Florida Department of Transportation

July 22, 2005

SUBJECT: Structures Temporary Design Bulletin C05-07
Roadway Design Bulletin 05-03
DCE Memorandum 15-05
Policy for Existing Roadway and Traffic Design Standards Index No.
401 Bridge Railing Retrofits

W-BEAM BRIDGE TRAFFIC RAILING RETROFITS

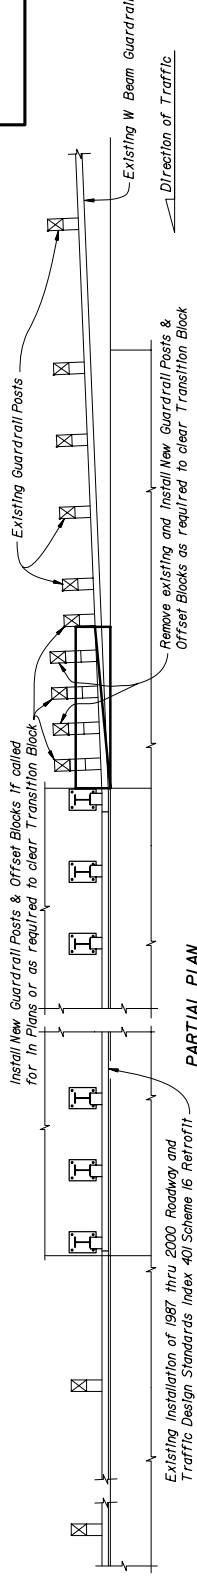
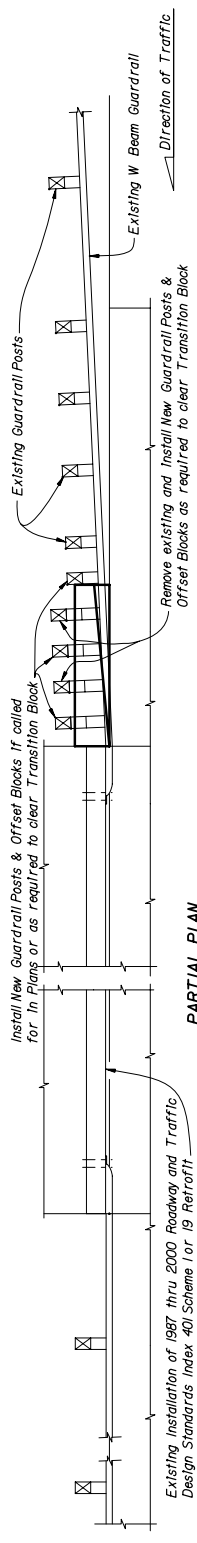
- Do not bolt nested W Beam to Posts and Offset Blocks at Posts (a), (c) & (e), (Typ.)
